Application of Jared Samples to rezone property from C-1 (Local Commercial) zoning district to MR-2 (Medium Density Residential-2) zoning district to allow for residential development, at 5561-5567 Memorial Drive.

PETITION NO: N3-2026-1100 Z-26-1248190

STAFF ANALYSIS

CASE NO.:	Z-26-1248190	File ID #: 2026-1101
Address:	5561 Memorial Drive, Stone Mountain, GA 30083	Commission Districts: 4 and 6
Parcel ID(s):	18 070 03 008	
Request:	Rezone property from C-1 (Local Commercial) zoning district to MR-2 (Medium Density Residential-2) zoning district to allow for a residential development.	
Property Owner(s):	Chaz Lazarian/Insignaia, LLC.	
Applicant/Agent:	Jared Samples	
Acreage:	13.1	
Existing Land Use:	CRC (Commercial Redevelopment Corridor)	
Surrounding Properties:	North: CRC, SUB South: CRC, SUB (Suburban), East: CRC, SUB, Pine Lake City Limits West: COS (Conservation)	
Adjacent Zoning:	North: C-1 South: MR-1 (Medium Density Residential-1) East: C-1 West: C-1	
Comprehensive Plan:	Consistent X	Inconsistent

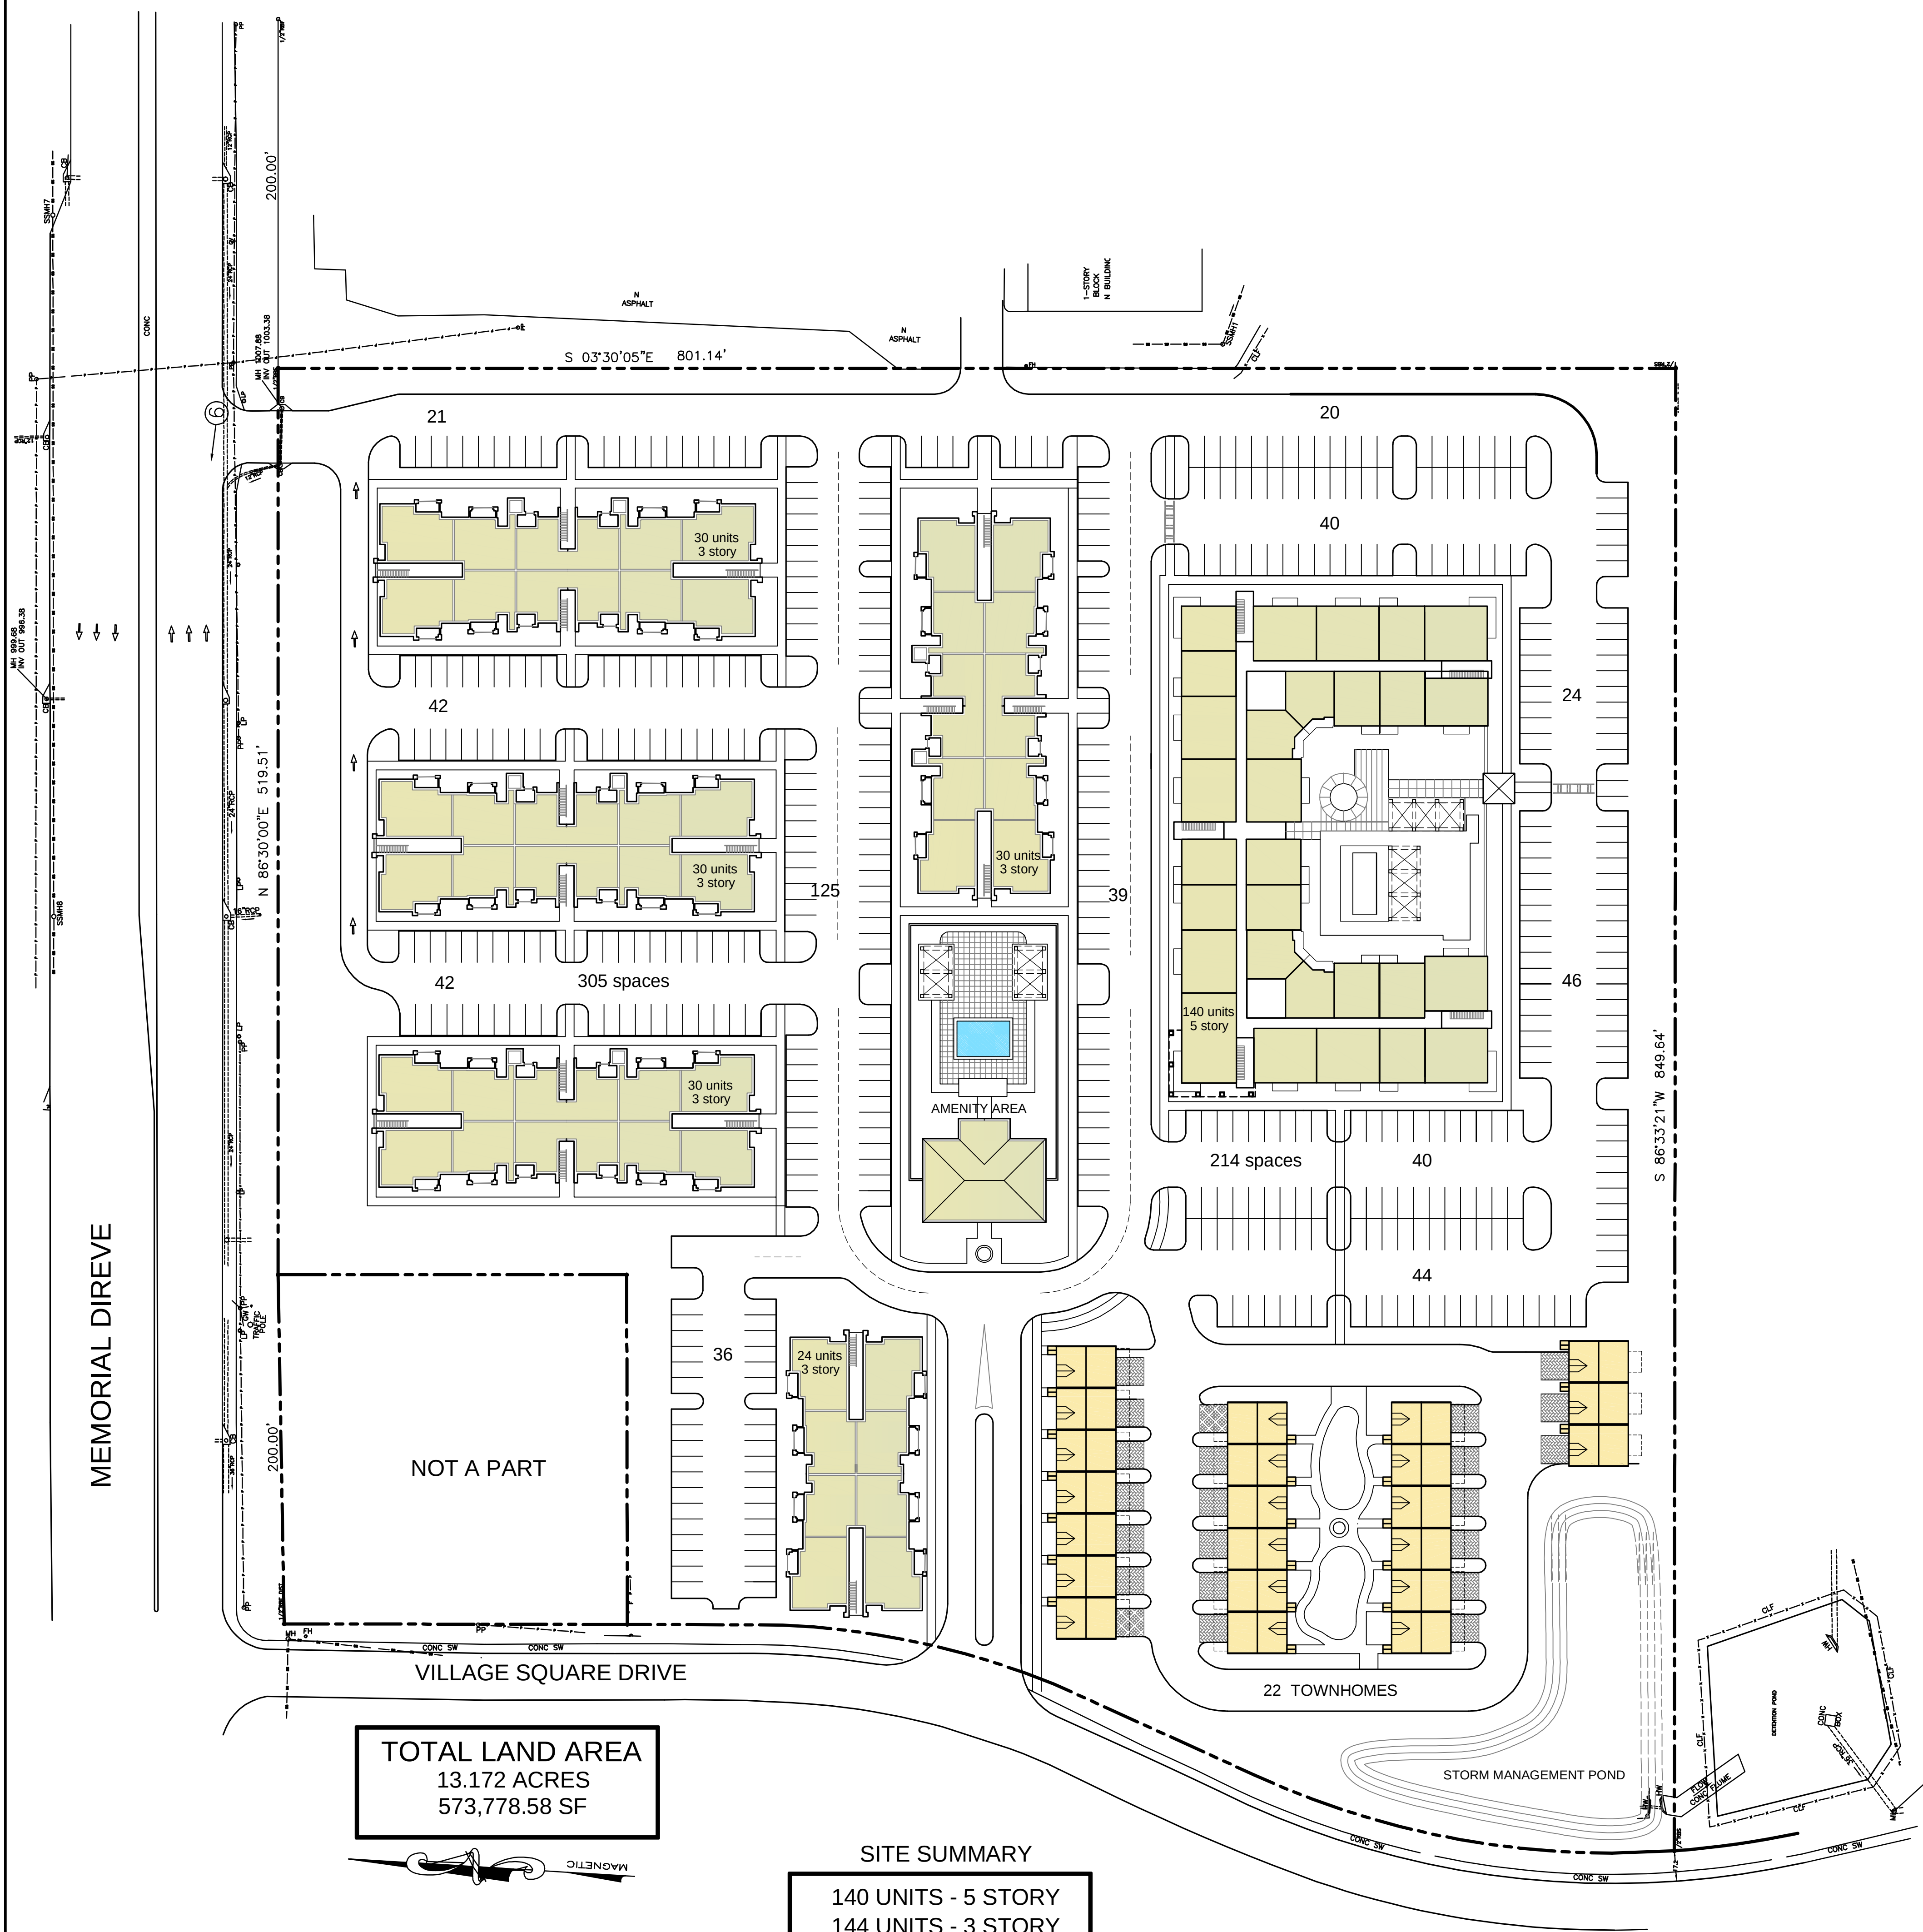
Revisions are necessary to address the scale and transition of development in relation to adjacent properties. The site is subject to a fifty-foot (50-foot) transitional buffer along the eastern and southern property lines pursuant to Section 5.4.5 (*Transitional Buffers*), which would provide separation between the proposed multifamily development and adjoining properties.

The SAP emphasizes rethinking the purpose and layout of the site and contemplates smaller-scale commercial uses balanced with residential development. Village Square is proposed as part of the “*Hambrick Village Focus Area*”, a site positioned for redevelopment, distinguishing this area from other portions of the corridor where preservation of the existing commercial development pattern was generally preferred. *Hambrick Village* is recognized in the SAP as an opportunity to establish an NC but also implies incremental density was desired rather than simply increasing building height and overall development intensity.

The revised site plan (8/11/26) does not demonstrate compliance with Section 5.4.5 (*Transitional Buffers*) or Section 2.14.6 (*Building Heights*) of the MR-2 zoning district. Additionally, several applicable MR-2 development requirements, including open space and streetscape requirements, are not sufficiently identified or demonstrated on the conceptual site plan. Given the approximately 13-acre size of the property, its prominent location along Memorial Drive, and its specific identification as a redevelopment opportunity in the Memorial Drive Corridor SAP, Staff finds that additional consideration of the proposed site organization, mix of uses, and overall Neighborhood Center (NC) character is warranted.
